Access Compliance Report

Public Rights-of-Way

(Curb Ramps)

Intersection ID: 9189	Main Street: DRUID_CR	Cross Street: STATESVILLE_AV	Location: SE
ADA ID: B1C83661DEAF	Ramp Type: Directional1	Initial Pass/Fail: Fail	Overall Compliance: No
Severity Score: 1.25			
Codes/Mitigation Info/Possible Solution		Field Measurements/Component Compliance

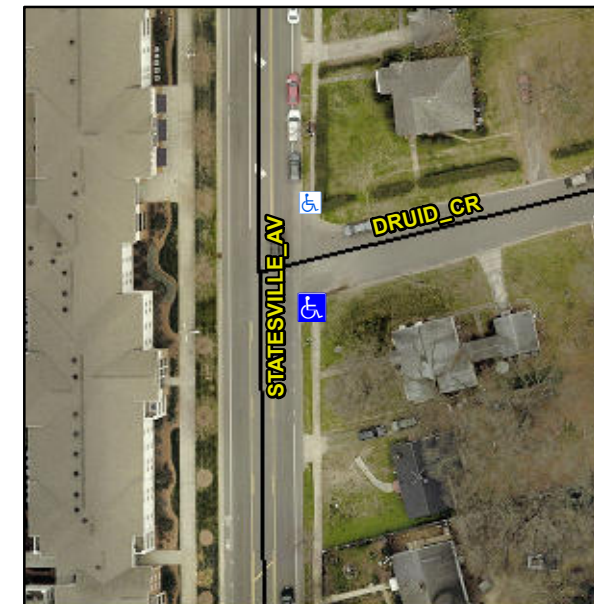
Remove & Replace Entire Ramp.

R304.5.3
